**Additions and Renovations  
Platt Technical High School  
Milford, CT**

**ADDENDUM NO. 2**

July 29, 2019

**SOUTH ELEVATION**

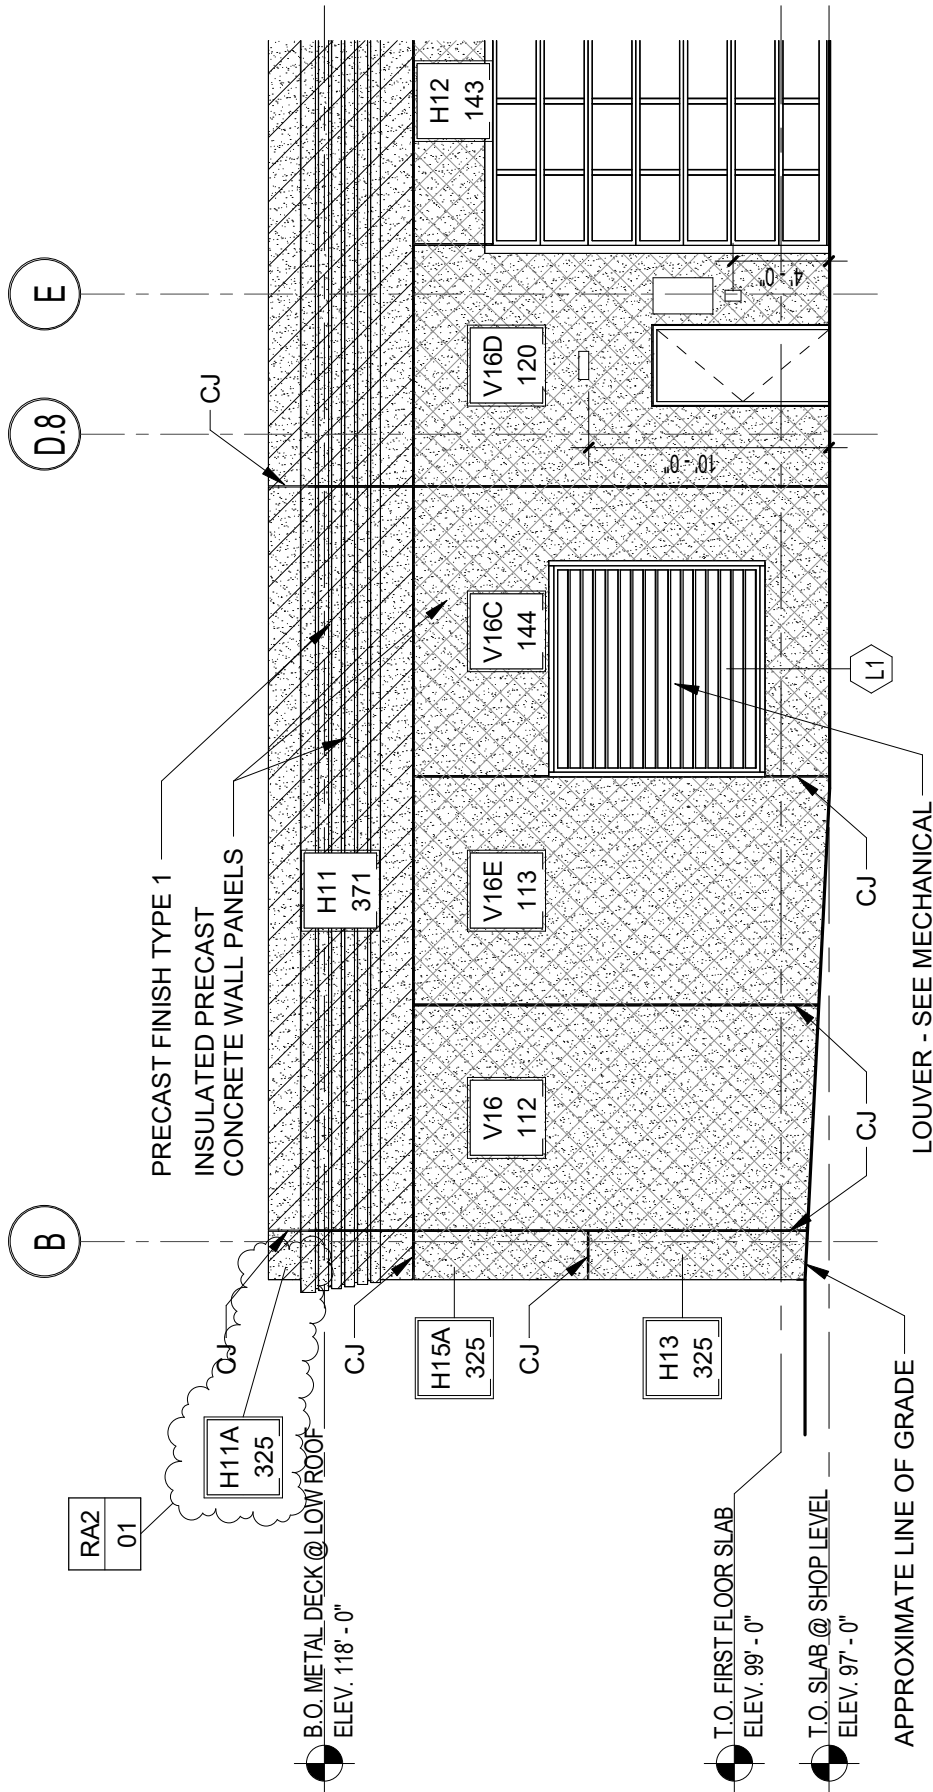
- ADD 2-017      A2-1-2 – BUILDING ELEVATIONS**  
Elevation 3, South Elevation: REVISE location of Pre-cast Elevation tag H11A-325. Refer to sketch RA2-01.

RA2-02

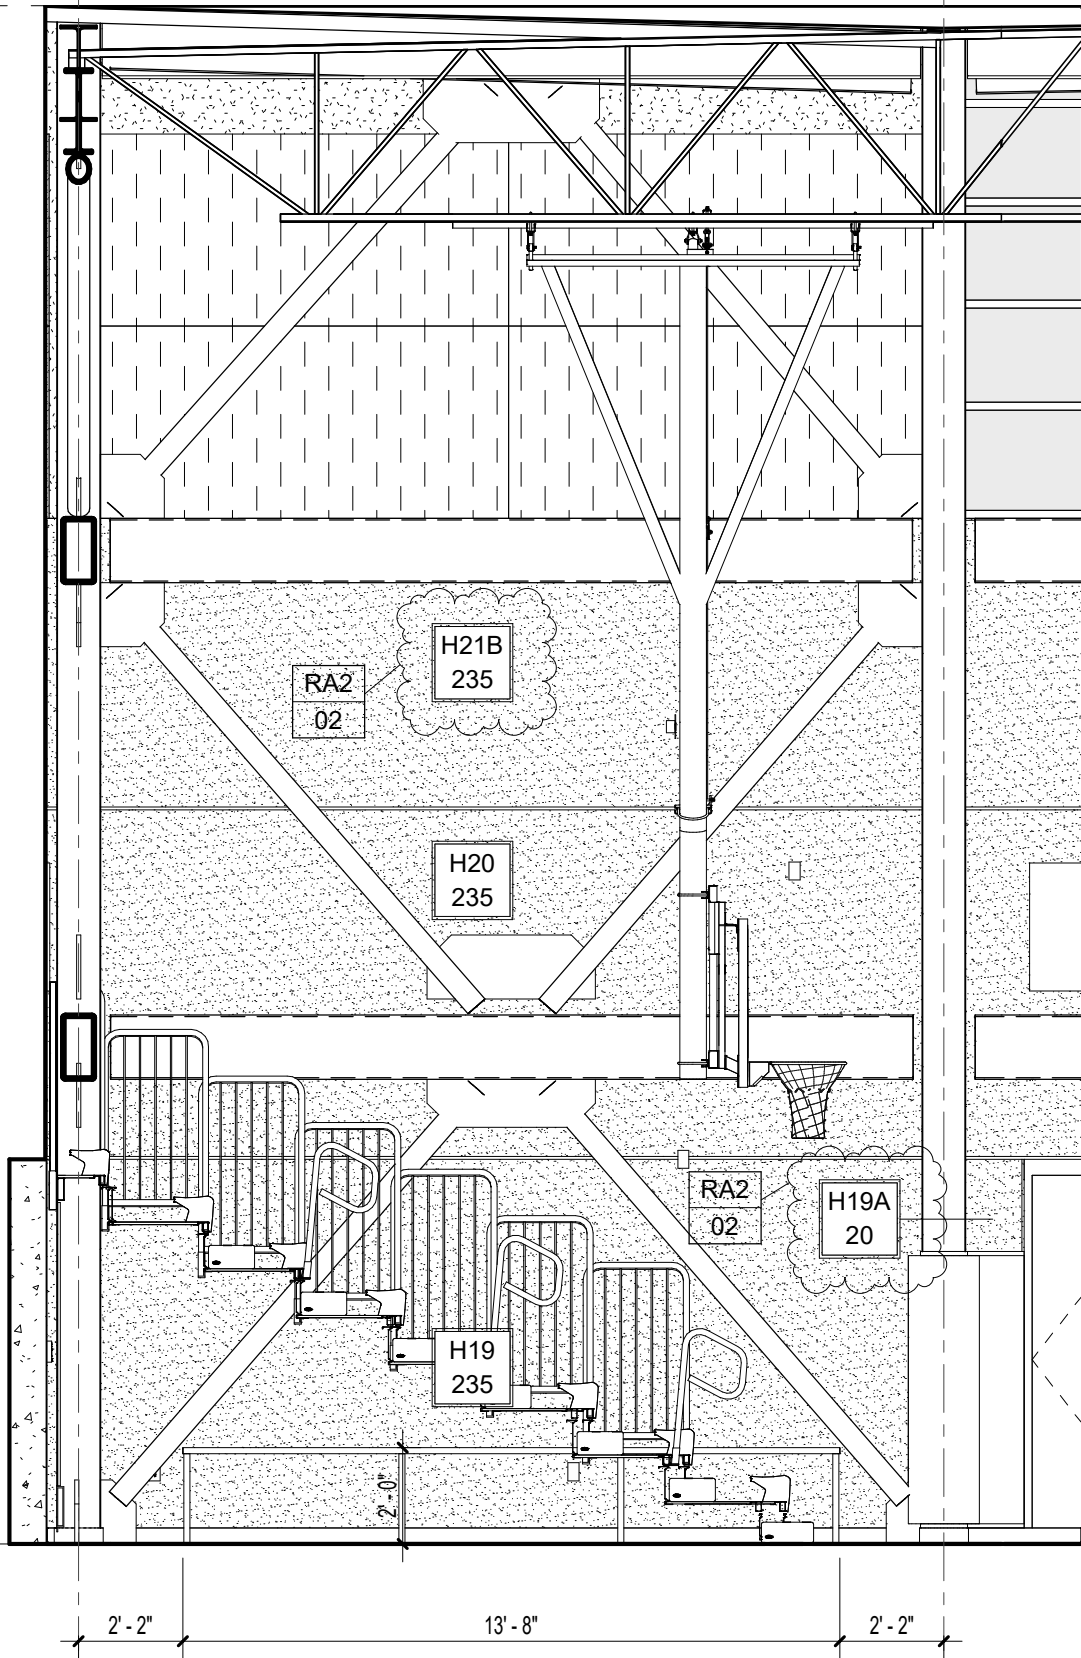
- ADD 2-018      A2-2-5 – INTERIOR ELEVATIONS**  
Elevation 2, Interior Elevation – Gymnasium West: ADD Pre-cast Elevation Tag “H19A-71” to the left of column line 19, just below pre-cast panel H20-308. Refer to sketch RA2-03.  
Elevation 2, Interior Elevation – Gymnasium West: ADD Pre-cast Elevation Tag “H21B-235” to the left of column line 17, just above pre-cast panel H20-235. Refer to sketch RA2-02.  
Elevation 2, Interior Elevation – Gymnasium West: ADD Pre-cast Elevation Tag “H19A-20” to the right of column line 17, just below pre-cast panel H20-308. Refer to sketch RA2-02.

**RA2-04**

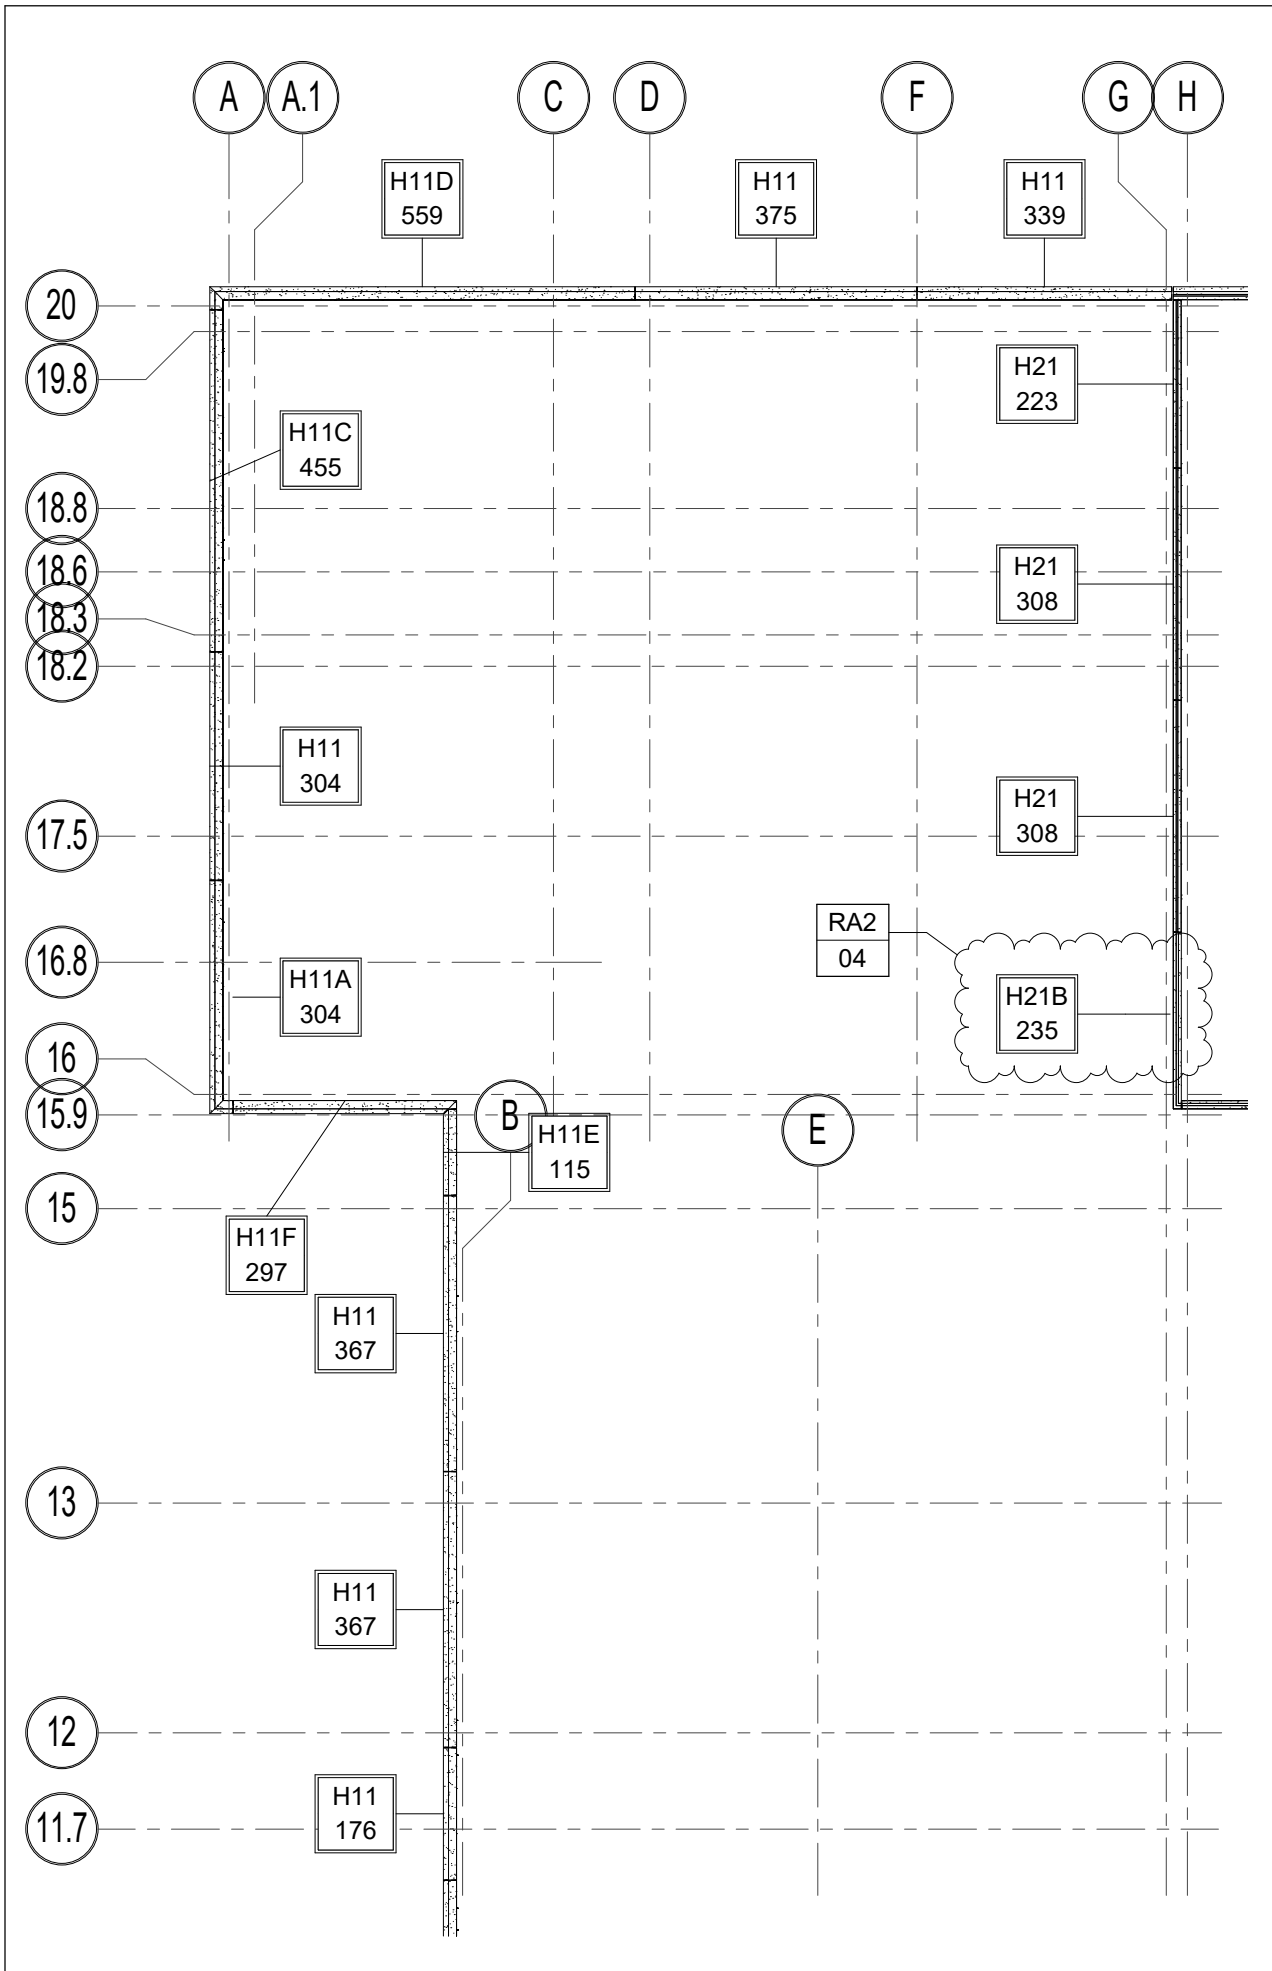
- ADD 2-019      A3-4-2 – OVERALL SECOND FLOOR PRECAST PANEL LAYOUT**  
ADD pre-cast identification tag at the Gymnasium along column line H between 16 and 17. Refer to sketch RA2-04.

1 FIRST FLOOR PLUMBING BELOW SLAB - AREA A  
 1/8" = 1'-0"  
 FFE: 99  
 REFER TO DRAWING P3-1-1 FOR PLUMBING LEGENDS.  
 REFER TO DRAWING P3-1-2 FOR SCHEDULES & FIXTURE CONNECTION SCHEDULE.  
 REFER TO DRAWINGS P4-1-1, P4-1-2 & P4-1-3 FOR PLUMBING DETAILS.

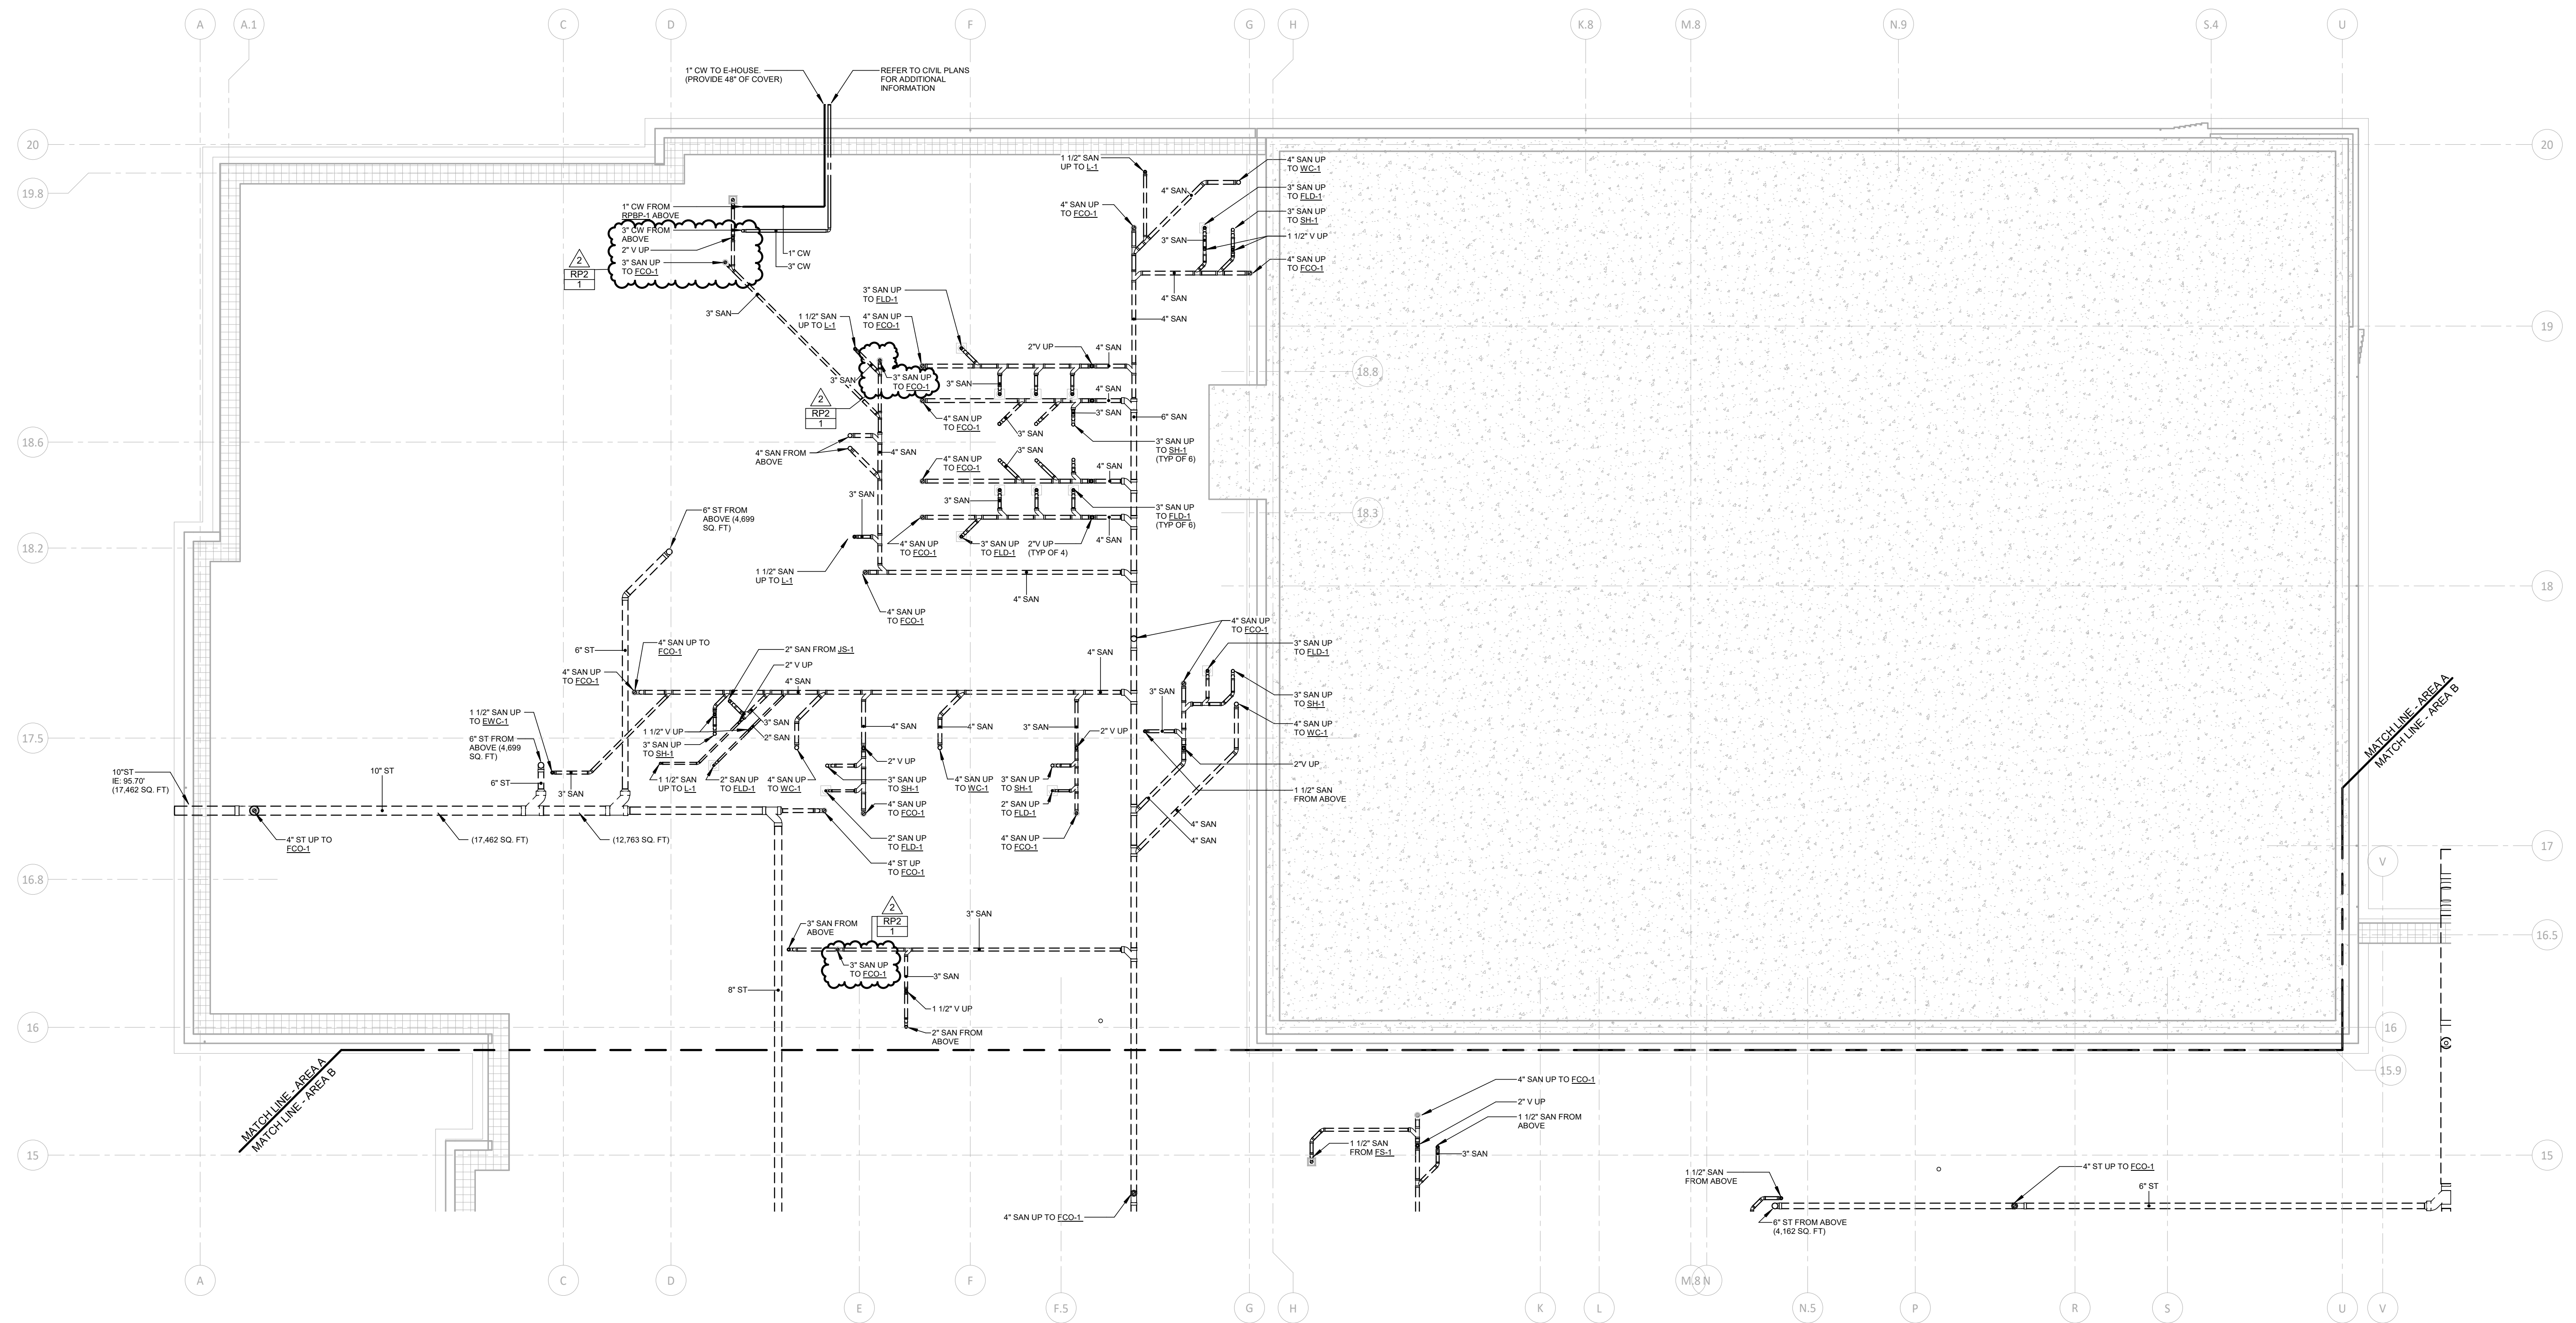
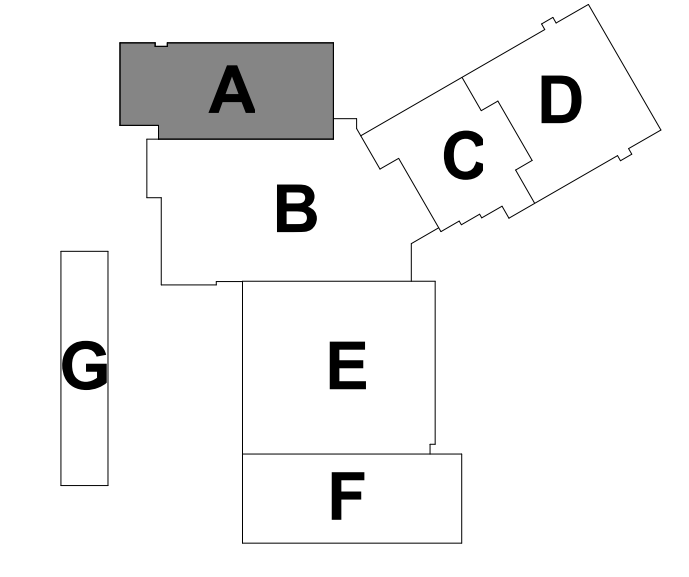
- ADD 2-020      DRAWING P1-1-UA – UNDERSLAB PLUMBING PLAN – AREA A**  
Added floor clean outs (FCO-1) and piping per Revision RP2-1.
- ADD 2-021      DRAWING P1-1-UB – UNDERSLAB PLUMBING PLAN – AREA B**  
Added floor clean outs (FCO-1) and piping per Revision RP2-2.  
Modified piping from FS-1 per Revision RP2-3.
